**Donegal Municipal District Active Travel Project
Bundoran to Ballyshannon, Co. Donegal**

REPORT NAME: Scheme 8 – Bundoran to Ballyshannon Part 8 Planning Report

Appendix B – Stage 1 Road Safety Audit

Figure 2-10: Proposed Crossing (Drawing 11199-08-1010-B)

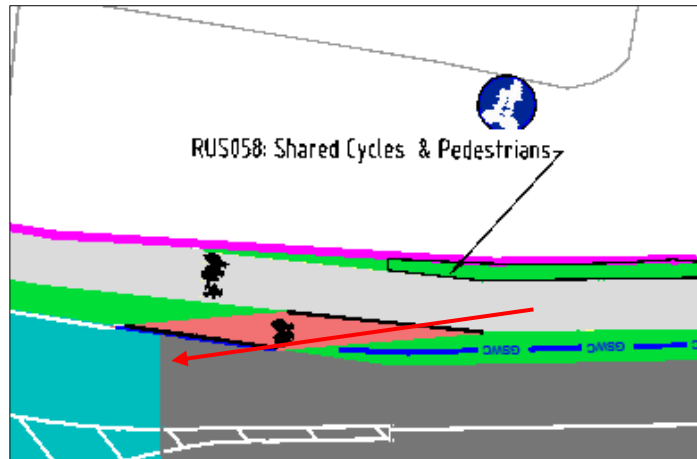
The Audit Team noted northbound cyclists can access the cycle lane from the roadway through a gap in the grass verge. The concern is cyclists traveling southbound may enter the carriageway towards opposing vehicles. This may result in a collision between a vehicle and a cyclists.

The design team should provide infrastructure to allow both direction of cyclists to depart and re-enter the carriageway in a safe manner.

Figure 2-11: Road Marking Design (Drawing 11199-08-1010-B)

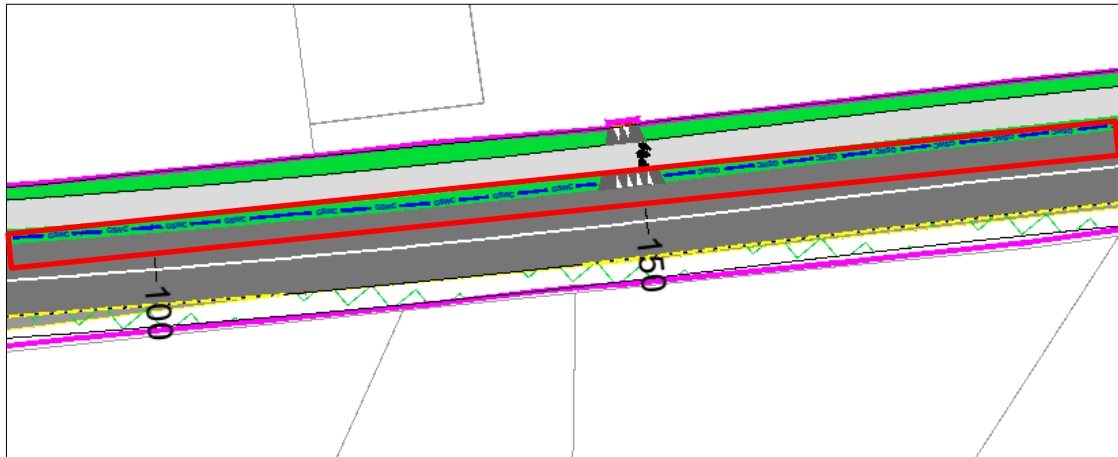
The Audit Team noted that no road edge markings are proposed in rural areas of the scheme. The Audit Team are concerned vehicles may not be able to determine the road edge and veer into the proposed scheme. This may result in a collision between a vehicle and a cyclist.

The design team should provide suitable road markings in rural areas at detailed design.

Figure 2-14: Proposed Layout (Drawing 11199-08-1012)

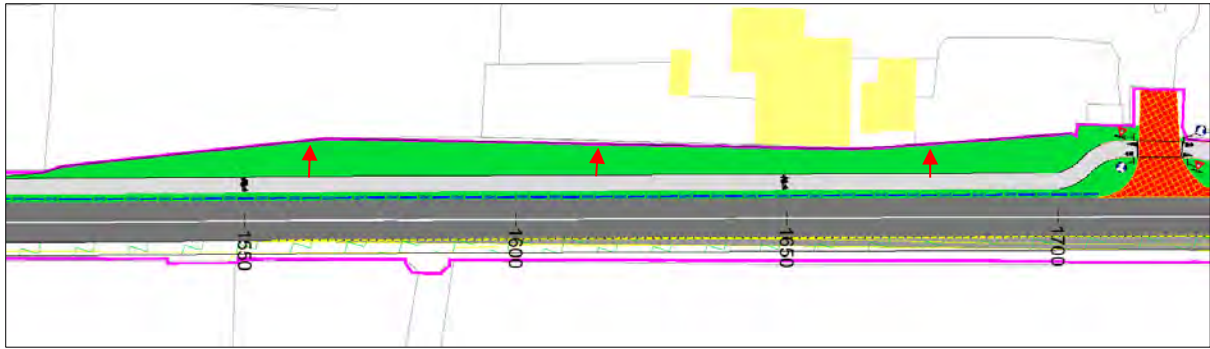
It was observed the cycle lane is adjacent to the road edge in areas where there is available space to provide greater separation between the motorists and VRUs. The Audit Team observed onsite, parking within the newly designed cycleway. The Audit Team are concerned vehicles may cross the cycleway to park in the area between the cycleway and boundary. This may result in a collision between pedestrian/cyclist and a vehicle.

The design team should provide separation where available between cyclists and motorists.
